SERVICE BULLETIN

FLIGHT CONTROLS – INSTALLATION OF AN ALERTING PLACARD ABOUT MAXIMUM SPEED TO PITCH-TRIM AFTER TAKEOFF

FLIGHT CONTROLS - MODIFICATION OF THE ELEVATOR FORWARD CONTROL SYSTEM TO COMPLY WITH 18-DEGREE FLAP IMPLEMENTATION

**FIGURE 1: INSTALLATION OF THE PLACARDS
(SHEET 01 OF 01)**

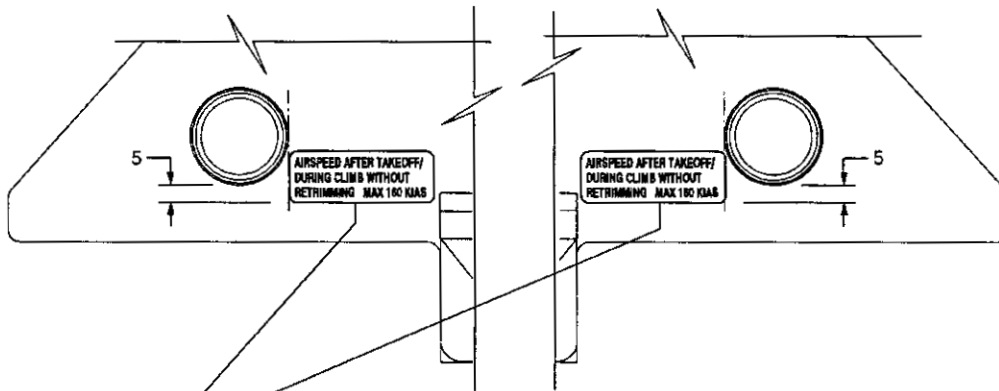
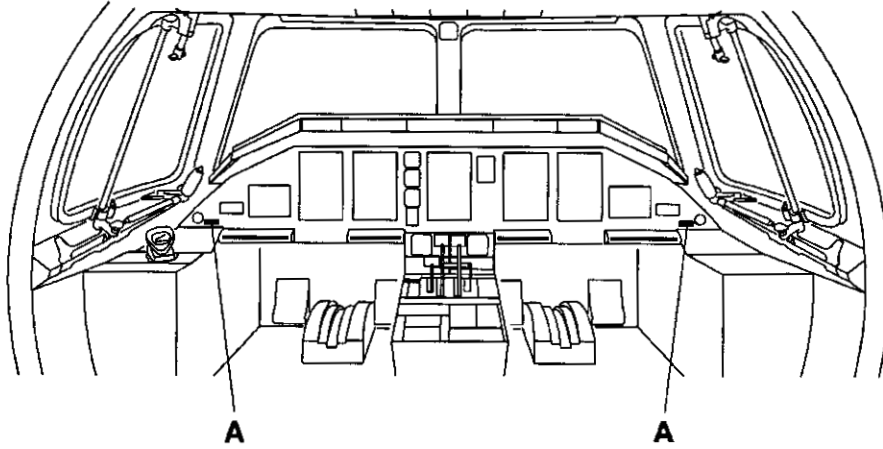
1. Make sure that the aircraft is safe for maintenance.
2. Install placards P/N 145-46718-001 (2 positions) on the main instrument panel by using adhesive tape P/N YR-9625. Refer to figure 1 or figure 2, according to the aircraft panel configuration, as well as to instructions in the applicable "Aircraft Maintenance Manual" – Chapter – 20-12-01 – Standard Practices – Airframe.
3. Restore the aircraft to normal.
4. Enter the accomplishment of this bulletin in the applicable document.

**AIRSPPEED AFTER TAKEOFF/
DURING CLIMB WITHOUT
RETRIMMING MAX 160 KIAS**

PLACARD
P/N 145-46718-001
(INSTALL)

**FIGURE 4: REPLACEMENT OF THE BELLCRANKS
(SHEET 1 OF 1)**

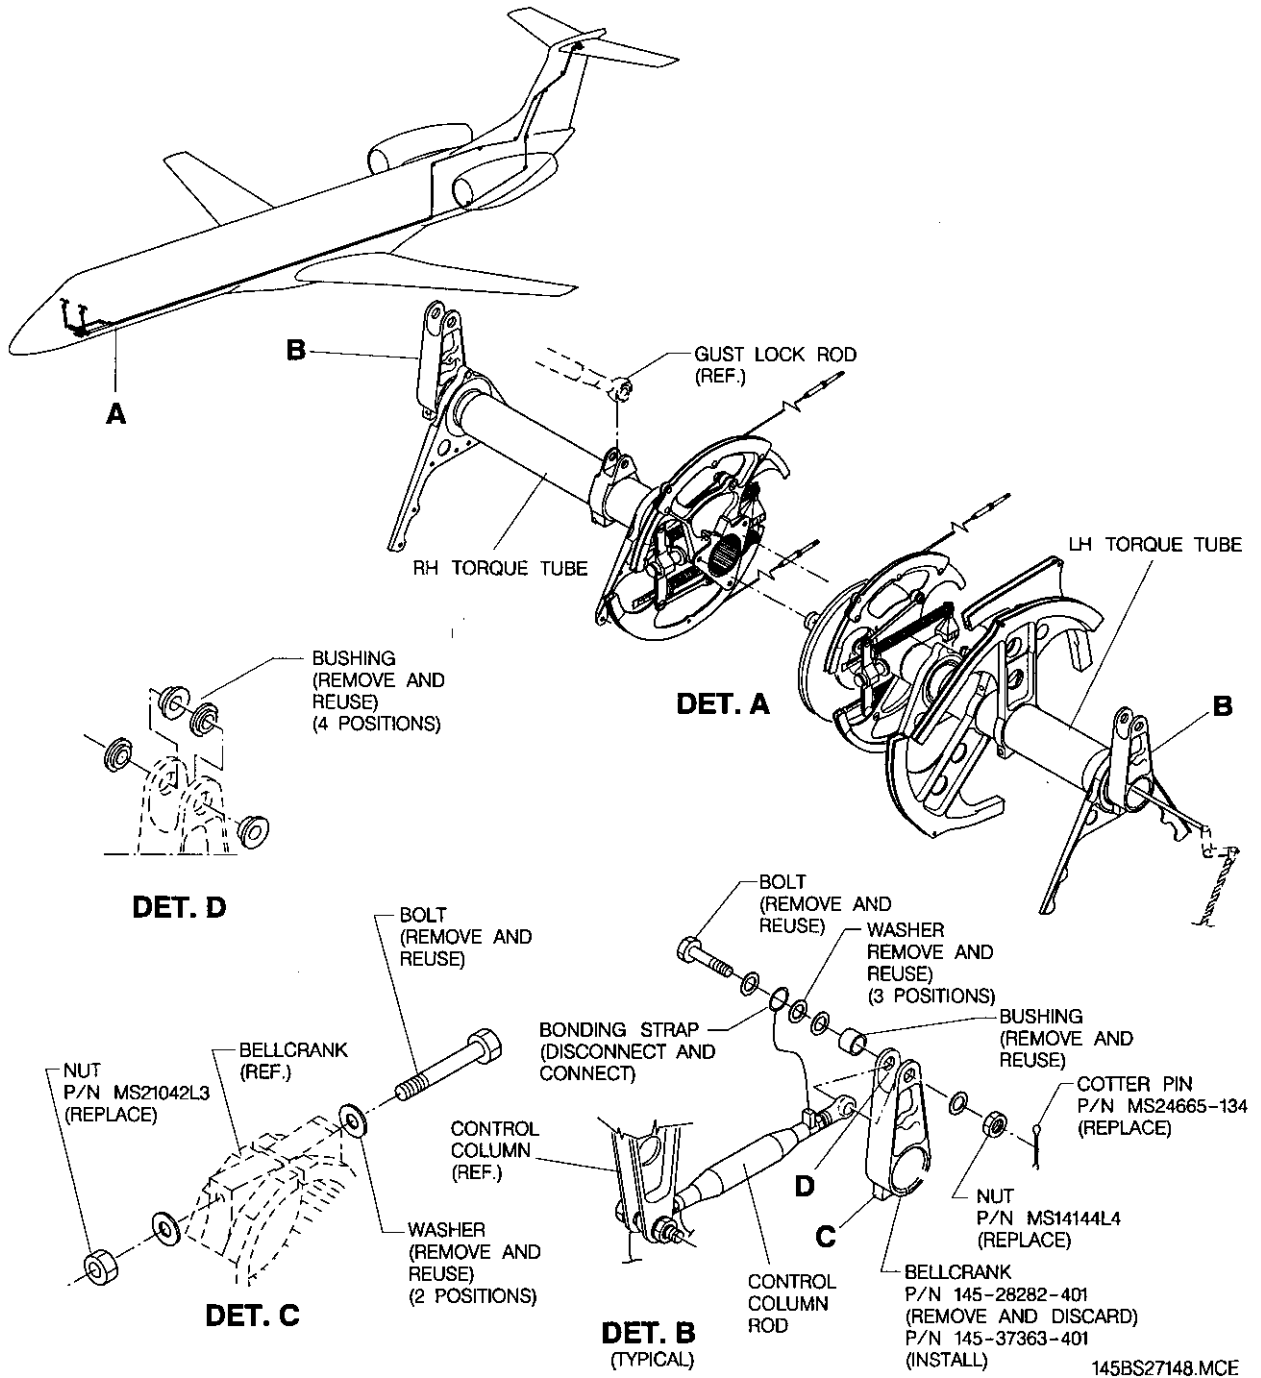
- K. Disconnect the end of the control column rods from the bellcrank at the LH and RH forward torque tube quadrants, by removing the cotter pin, nut, washers, bushing, bonding strap and bolt according to FIGURE 4.

- L. Replace bellcrank P/N 145-28282-401 from LH and RH forward torque tubes with bellcrank P/N 145-37363-401, according to FIGURE 4.
- M. Install rig pins on the LH and RH forward elevator torque tubes.

FIGURE 5: CONTROL COLUMN MODIFICATIONS
(SHEET 1 OF 1)

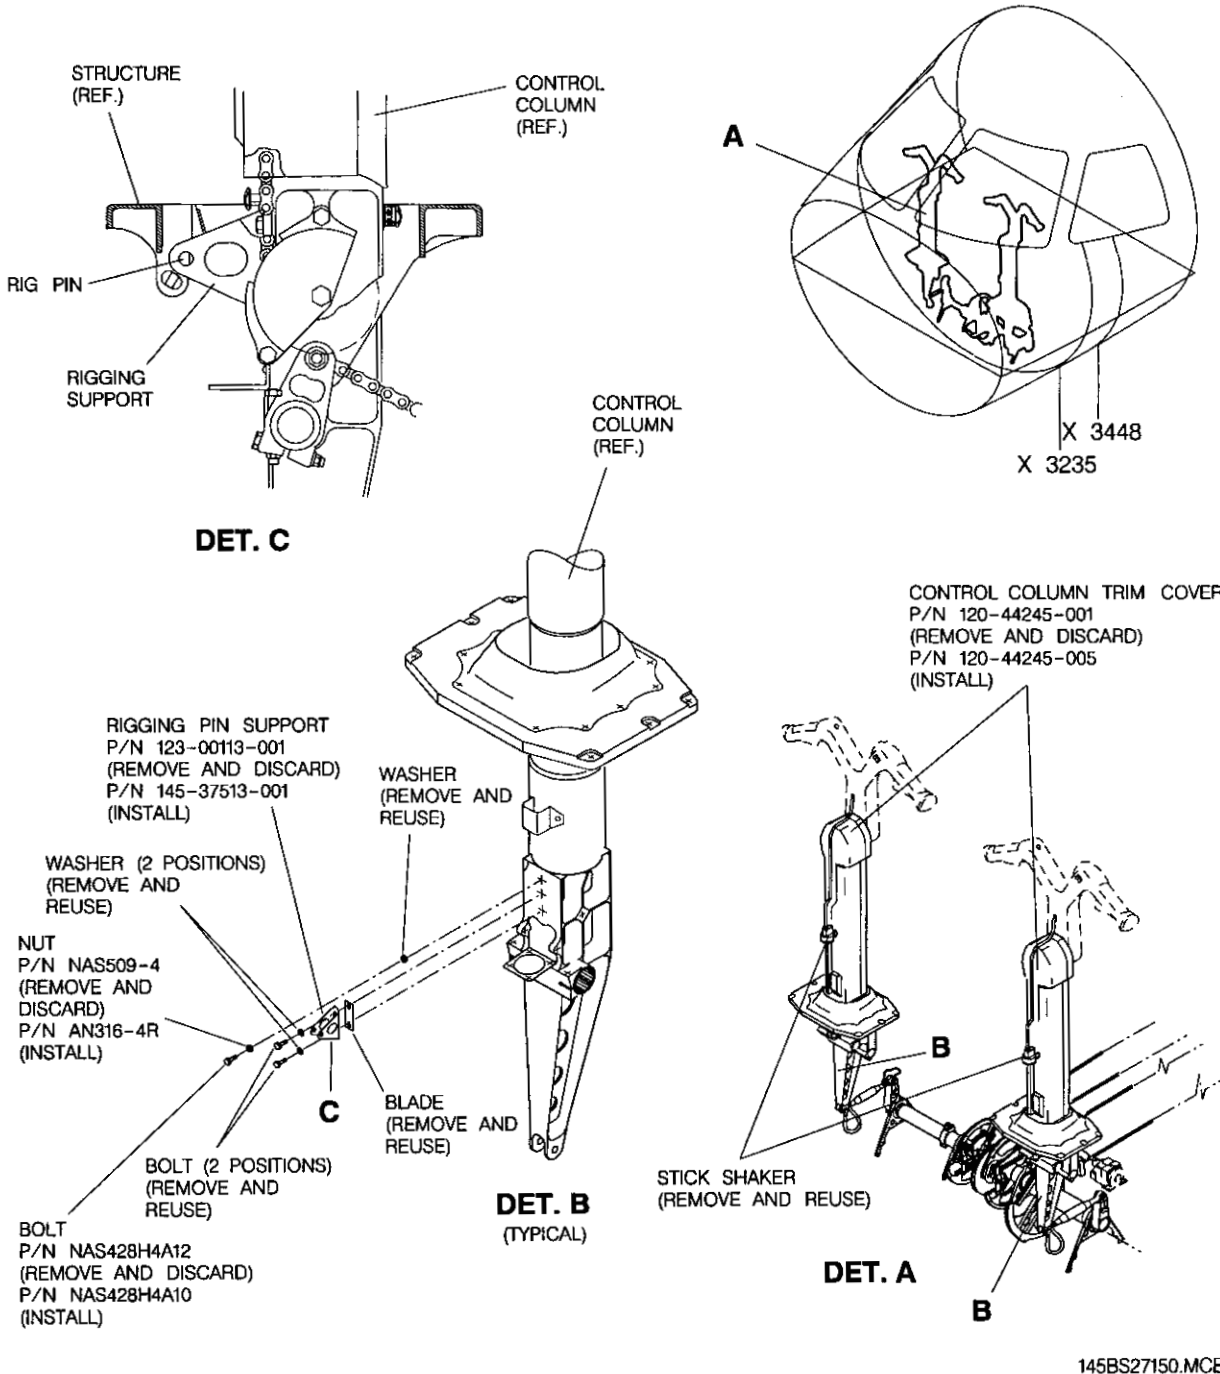
- H. Remove the stick shaker. Refer to the applicable "Aircraft Maintenance Manual" - Chapter 27-36-03 (TASK 27-36-03-000-801-A) - Flight Controls.
- I. Replace the LH and RH control column trim covers from P/N 120-44245-001 to 120-44245-005, according to FIGURE 5.

- R. Repeat steps "M" to "P" for the copilot control column.
- S. Replace the rigging support from LH and RH control columns P/N 123-00113-001 with rigging support P/N 145-37513-001 according to FIGURE 5. Proceed as follows:

- T. Replace the RH and LH nose-down backstops from the control column according to FIGURE 5.
- U. Adjust the elevator Primary and Secondary backstops. Refer to the applicable "Aircraft Maintenance Manual" - Chapter 27-31-00 (TASK 27-31-00-700-802-A).- Flight Controls.

- (a) Release and retain the bolts and washers which are attaching old rigging pin support;
 - (b) Remove and discard the old rigging pin support P/N 123-00113-001;

- (c) Position new rigging pin support P/N 145-37513-001 on the control column using the bolts and washers. Do not tighten them yet;
 - (d) Adjust the vertical position of the support in order to install the rig pin;

- (e) Tighten the bolts attaching new rigging pin support to the control column.

**FIGURE 6: REPLACEMENT OF THE GUST LOCK ROD
(SHEET 1 OF 1)**

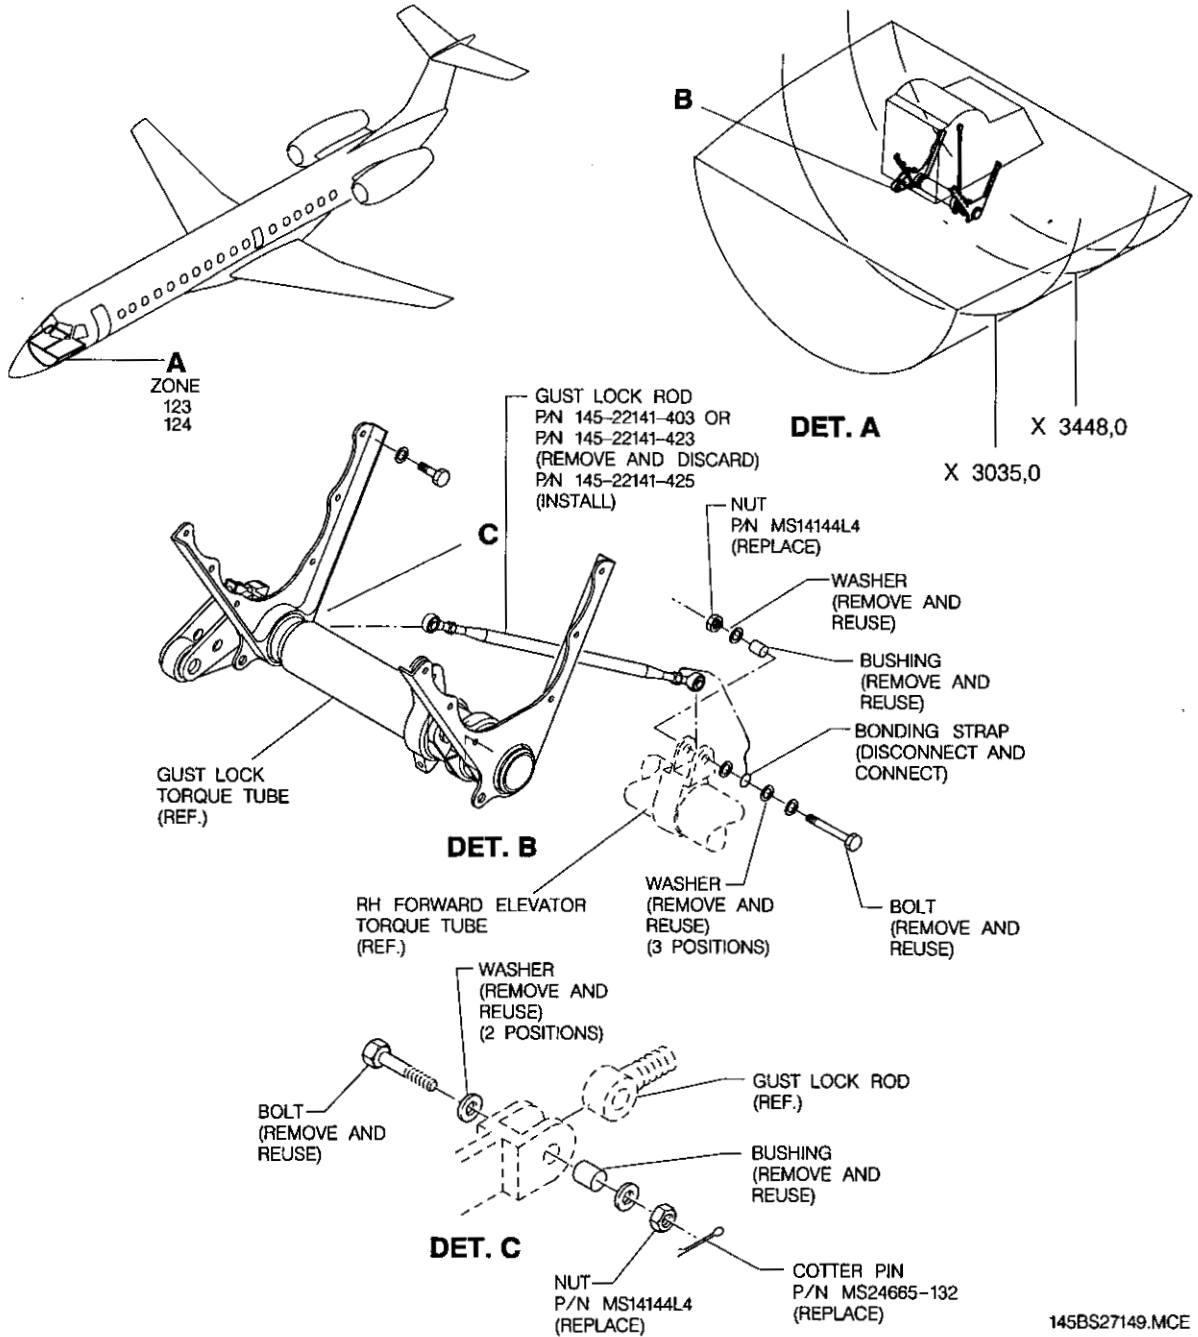
- J. Remove gust lock rod P/N 145-22141-403 or P/N 145-22141-423 from its bellcrank at the RH torque tube quadrant, by removing the cotterpin, nut, washers, bushing, bonding strap and bolt, according to FIGURE 6.

- V. Install new gust lock rod P/N 145-22141-425 to its bellcrank at the RH torque tube quadrant, installing the cotterpin, nut, washers, bushing, bonding strap, and bolt, according to FIGURE 6.
